Detroit
Edison

January 29, 1988
NRC-88-0004

Subject: Proposed Technical Specification (License Amendment) Change - Primary Containment Isolation Valves (3/4.6.3)

FIGURE 1

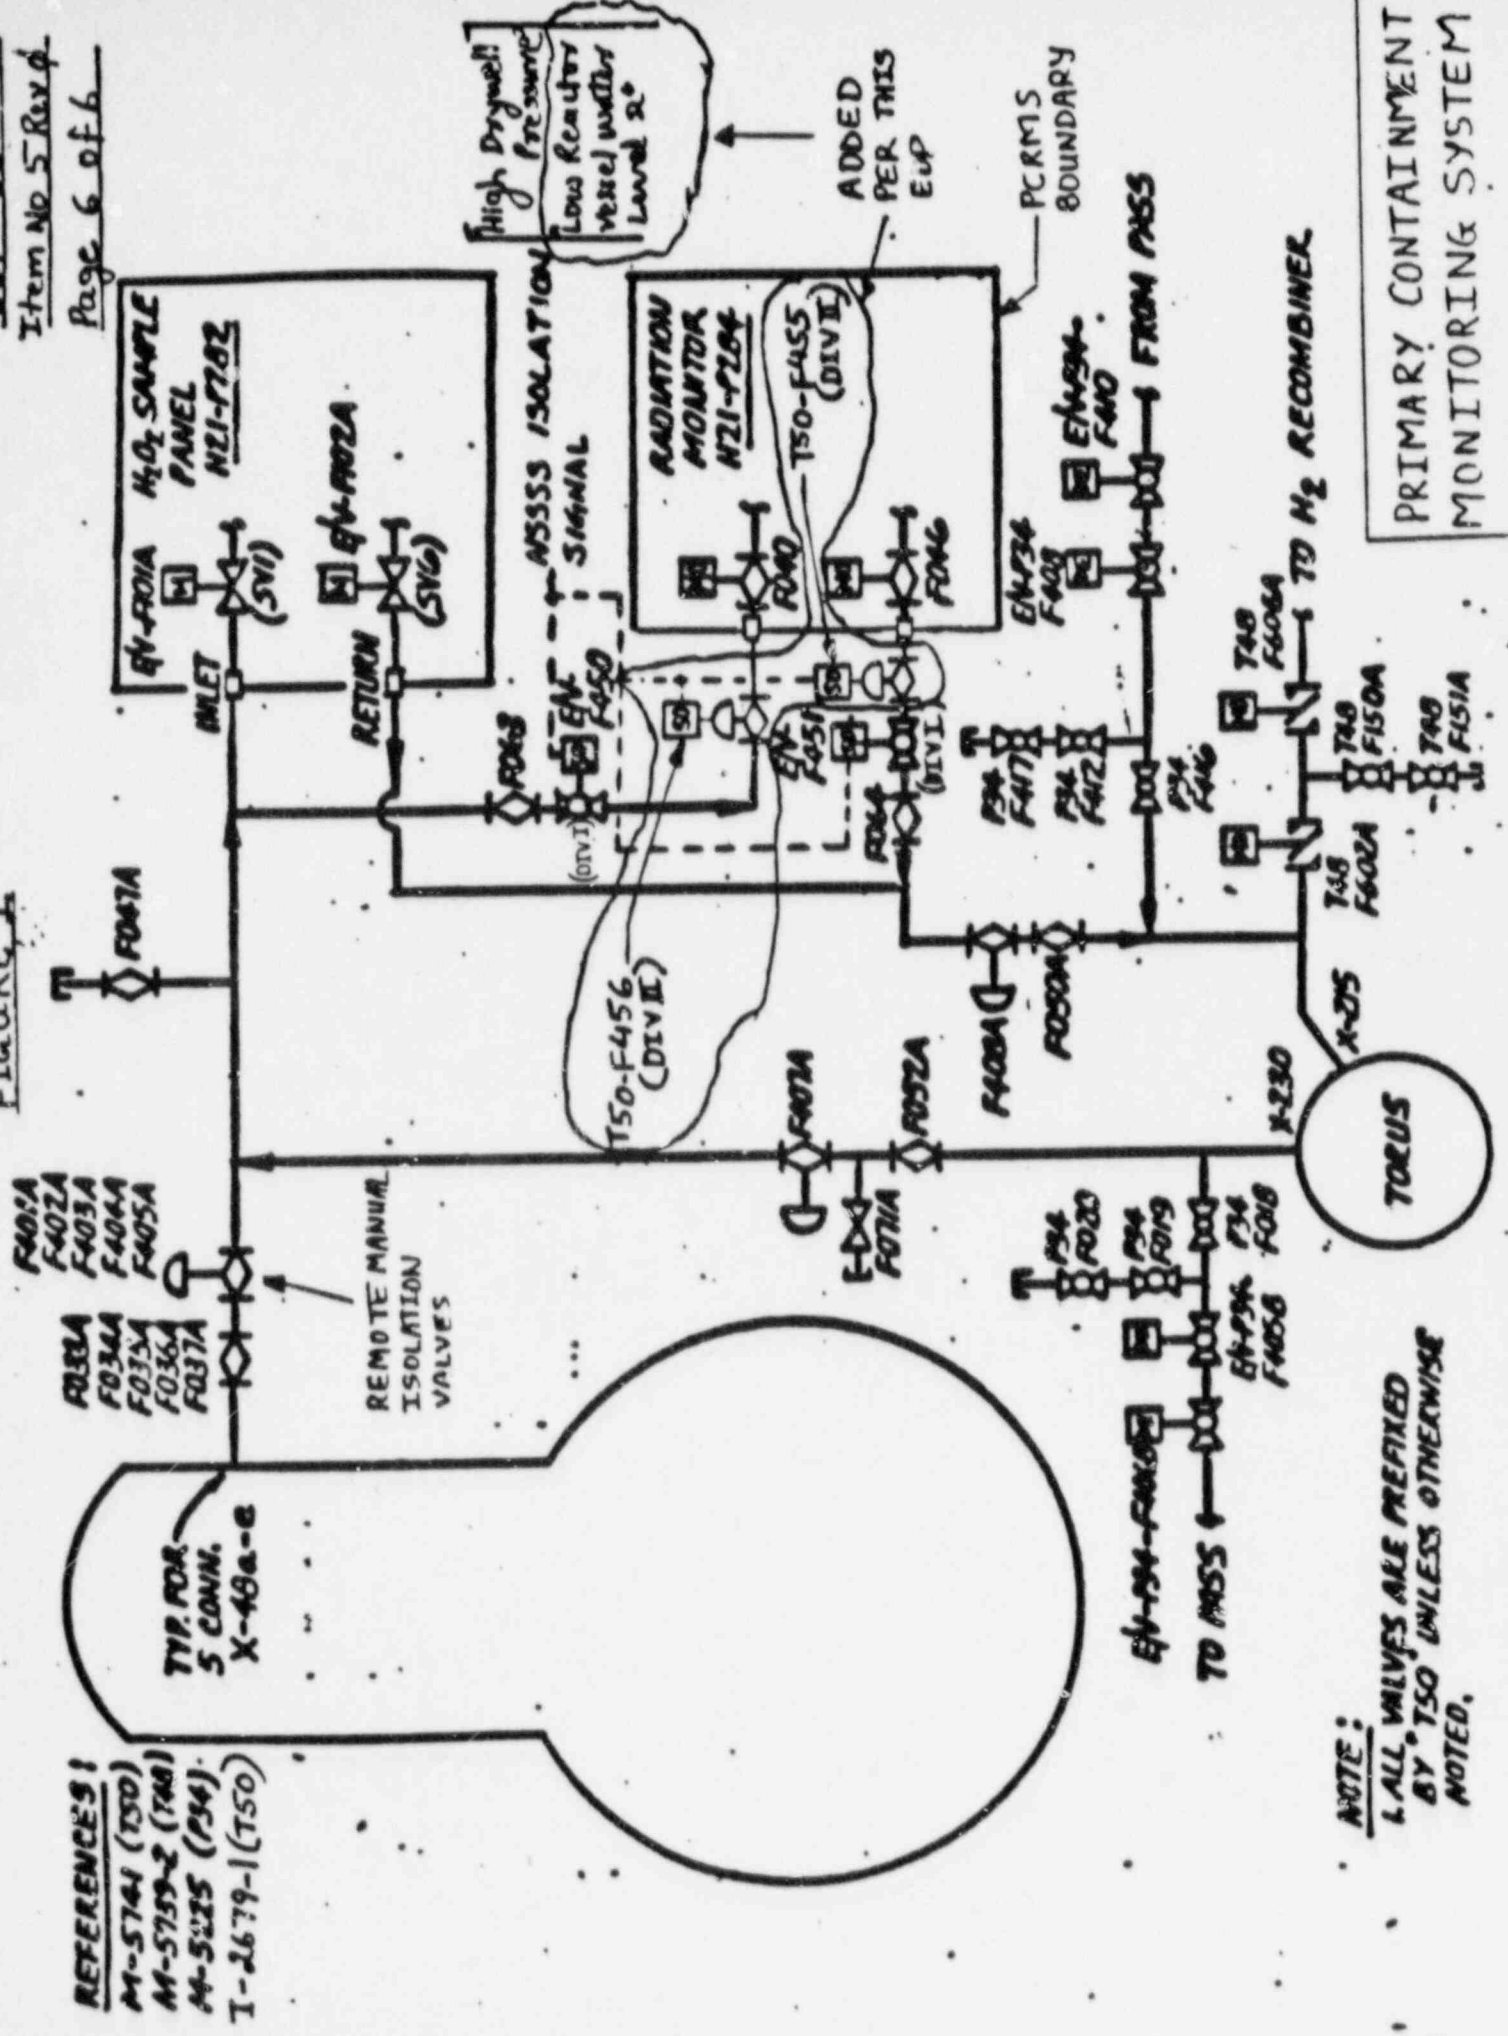
During an October 1987 maintenance servicing of the PCRMS, valves T50-F450 and T50-F451 were used to isolate the inlet and return lines of the system from the primary containment. This isolation procedure was reviewed by Fermi 2 operations personnel and questioned since these valves were not indicated as containment isolation valves in either the plant procedures or Technical Specifications. The PCRMS uses the penetration of the essential Drywell Hydrogen/Oxygen Sampling System by tapping off between the remote isolation valves and the panel. The valves used to isolate the PCRMS are located in these tap-off lines (see Figure 1).

The proposed design modification provides automatic isolation to the non-essential PCRMS from the essential PCAMS, thus maintaining PCAMS as a closed loop system outside containment. This results in PCRMS having two redundant and divisional automatic isolation valves on the inlet line and two redundant and divisional automatic isolation valves on the outlet line of the system. The subject isolation valves (as shown in Figure 1) consist of the existing Division I (T50-F450 and T50-F451) valves and the addition of Division II (T50-F455 and T50-F456) valves. These inlet and outlet lines for PCRMS are connected to Division I of PCAMS. The PCAMS is a closed loop system outside containment and is an extension of primary containment. Therefore, PCRMS lines can be considered as lines which penetrate primary containment.

The Fermi 2 Technical Specifications should be modified to include two new PCRMS automatic isolation valves (T50-F455 and T50-F456) in Table 3.6.3-1 (see proposed page changes). These valves are pilot solenoid air operated ball valves which incorporate the diversified automatic high drywell pressure and Level 2 isolation signals. The valves are proposed as Group 17 automatic isolation valves which require associated maximum isolation time of 60 seconds. This isolation time is based upon the guidelines established in Section 6.2.4 of the Standard Review Plan (NUREG-0800).

Additionally, the Fermi 2 Technical Specifications should be modified to include two PCRMS automatic isolation valves (T50-F450 and T50-F451) which had been previously installed. The design modification performed in January 1984 (discussed above), should have been reflected in Table 6.2.2, "Summary of Primary Containment Penetrations and Associated Isolation Valves," of the Final Safety Analysis Report (FSAR) to show valves T50-F450 and T50-F451 as isolation valves associated with containment penetrations X-48 a-e and X-215. The Fermi 2 Technical Specifications for primary containment isolation valves were developed primarily on the basis of FSAR Table 6.2-2. Reviews were made to ensure the adequacy of these documents; however, the valves were omitted from Technical Specification Table 3.6.3-1. This proposed amendment corrects this oversight. These valves are solenoid operated spring-to-close valves which will be modified to incorporate the diversified automatic high drywell pressure and Level 2 isolation signals. The valves are proposed as Group 17 automatic isolation valves which require associated maximum isolation time of 60 seconds. This isolation time is based upon the guidelines established in Section 6.2.4 of the Standard Review Plan (NUREG-0800).
